Product Change Notification

23-APR-2021 / PCN OMV-1179-2021 Rev. 0

TITLE: Redesign of IL300 Linear optocoupler product series

Details of Changes to IL300 Series Addressed in PCN OMV-1179-2021

3.3 Package

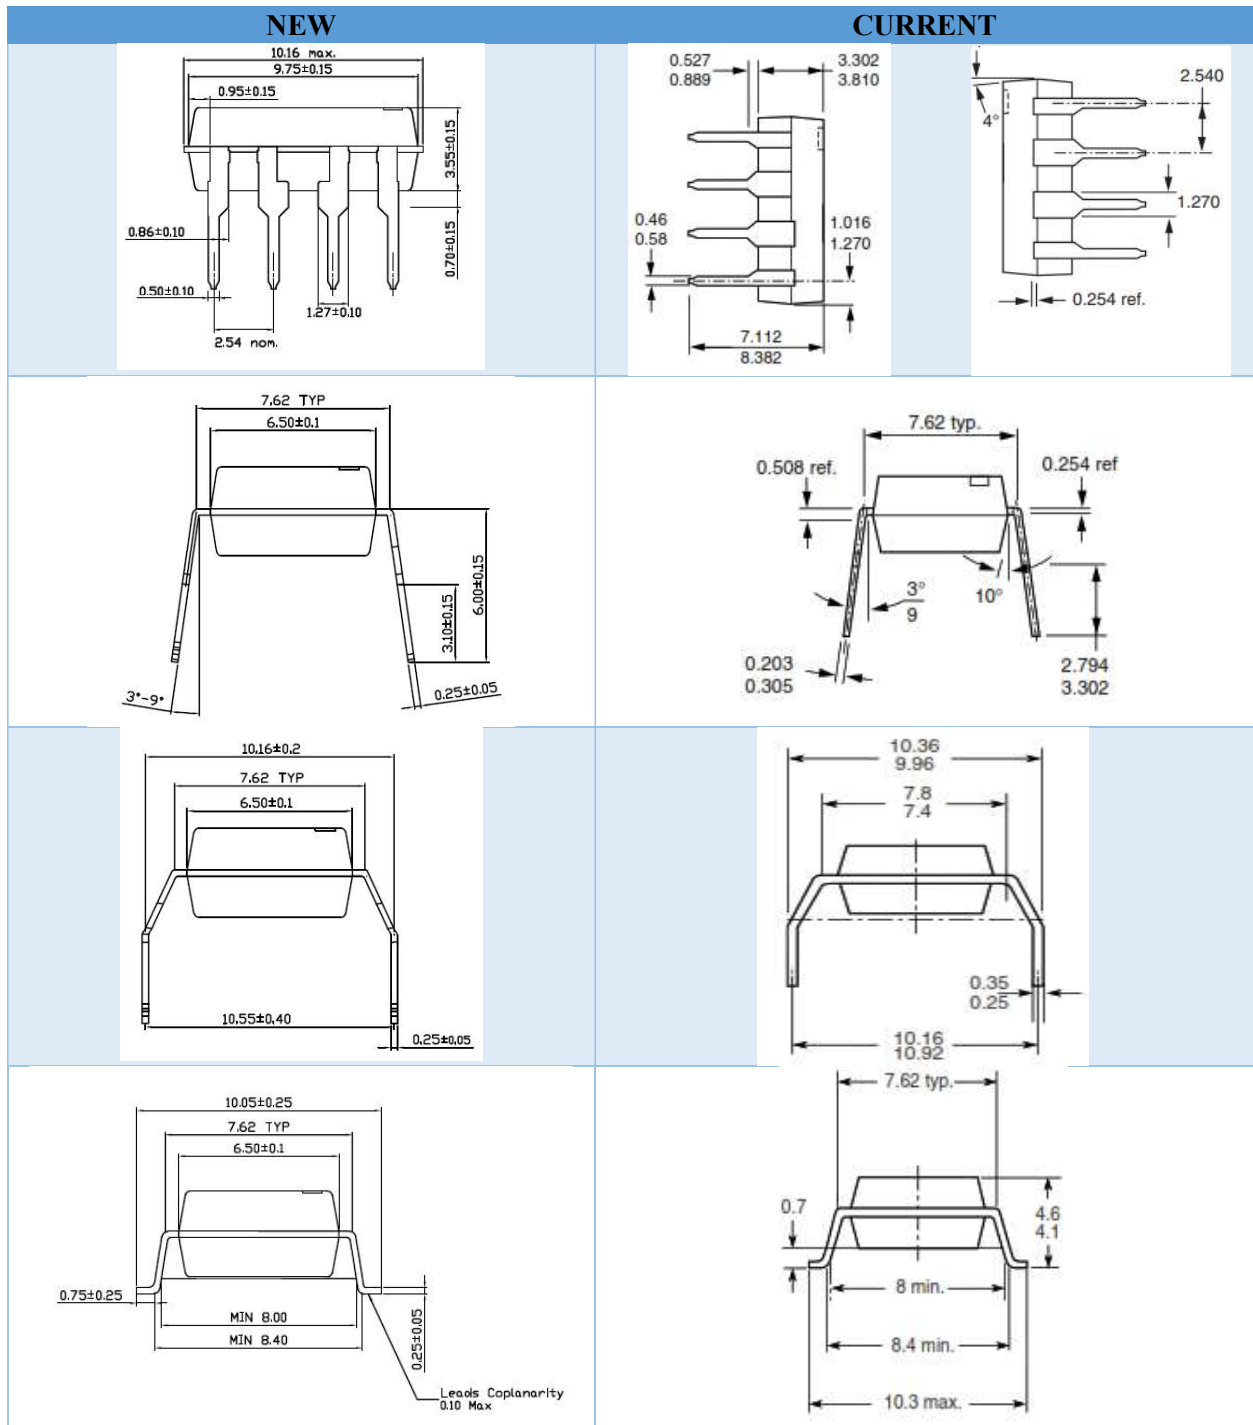
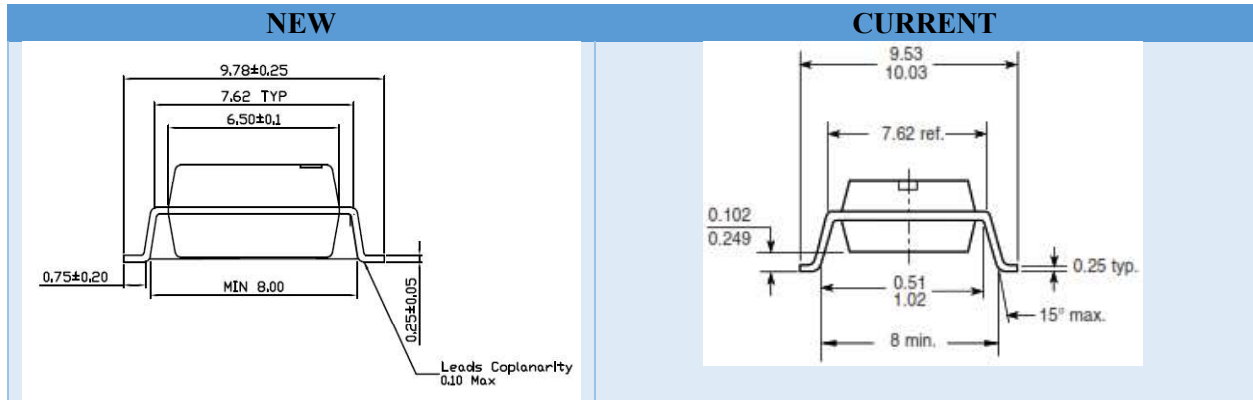
The package has been redesigned resulting in several changes. The most notable of these changes is the colour of the outer molding compound. Less noticeable is the change in construction and the change in package dimensions.

Package Dimension: The package still conforms to the JEDEC standard, some of the dimensions have slight changes.

3.7.1 Changes to Data Sheet limits.

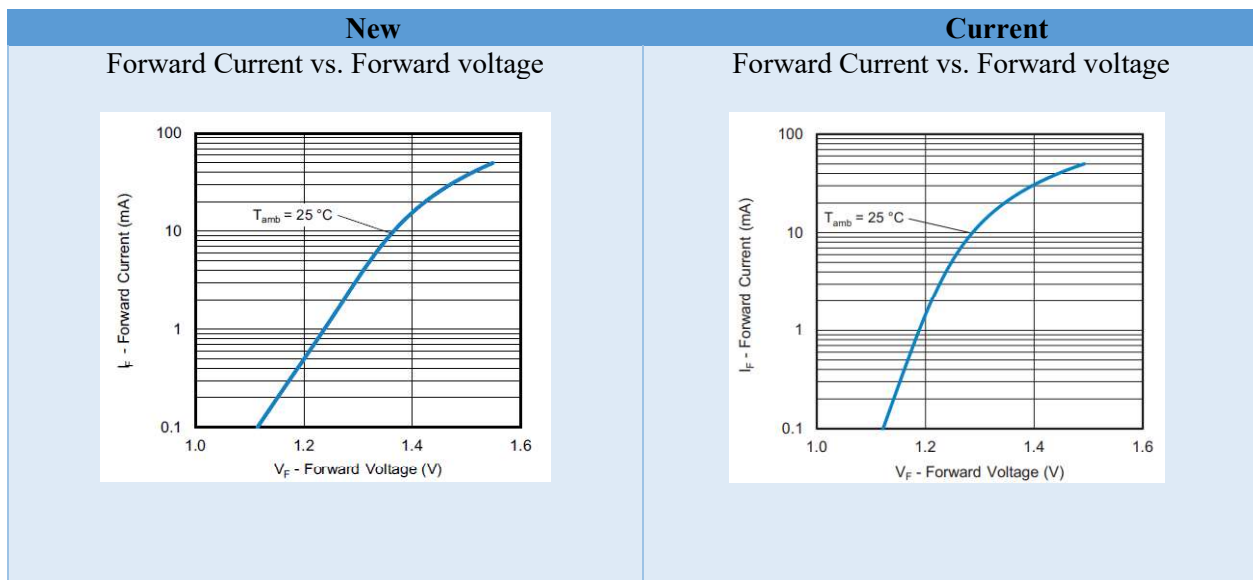
The following shows a comparison of the parametric limits that were changed in the data sheet as a result of this new design.
